New O'Reilly Auto Parts Store:
 O'REILLY AUTO PARTS
 4014 MARKET STREET
 WILMINGTON, NC

RE: Responses to comments dated May 8, 2013

5 HANDICAP PARKING SYMBOL
C3 SCALE: 3/4" = 1'-0"

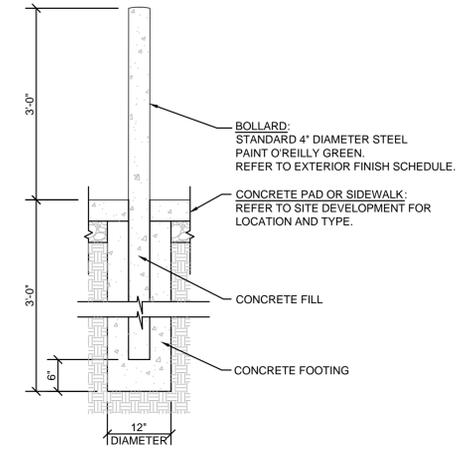
4. Please revise the Handicap Parking Symbol detail 5/C3, which is shown as yellow, to be painted to the current ADA standards. All pavement markings are to meet MUTCD standards. **The note has been revised such that the parking symbol should be painted white.**

10 DRIVEWAY DETAIL
C3 SCALE: 1" = 20"

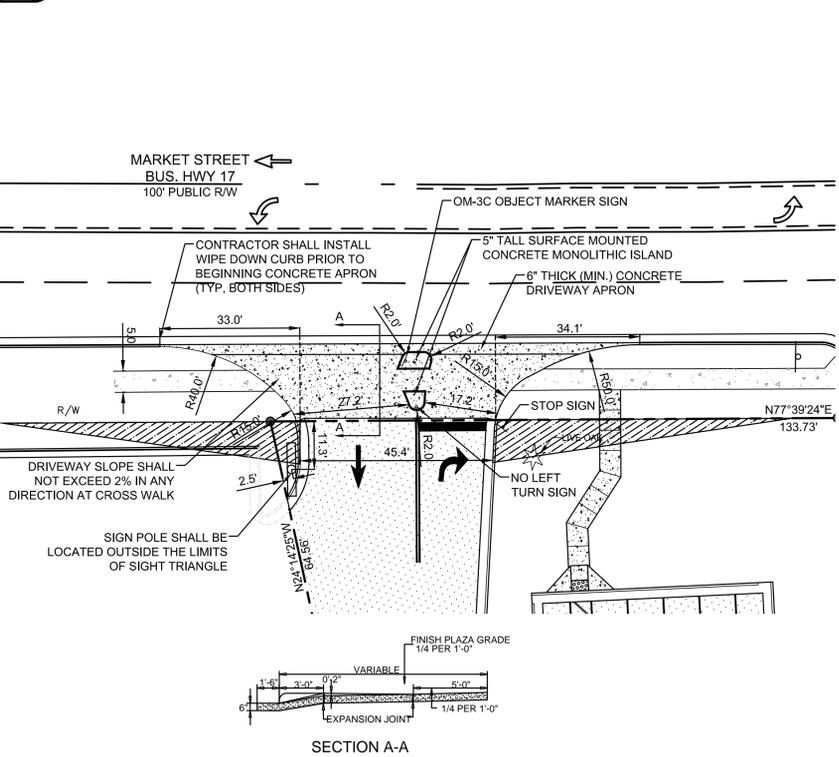
1. The approved driveway design is not standard; therefore, it is necessary to provide a detail. Please provide a detail drawing of the proposed driveway. It must meet the minimum standards of the City Standard Driveway Detail (concrete thickness, etc.). **A detailed enlargement of the driveway has been provided on sheet C3 in place of Wilmington's standard.**
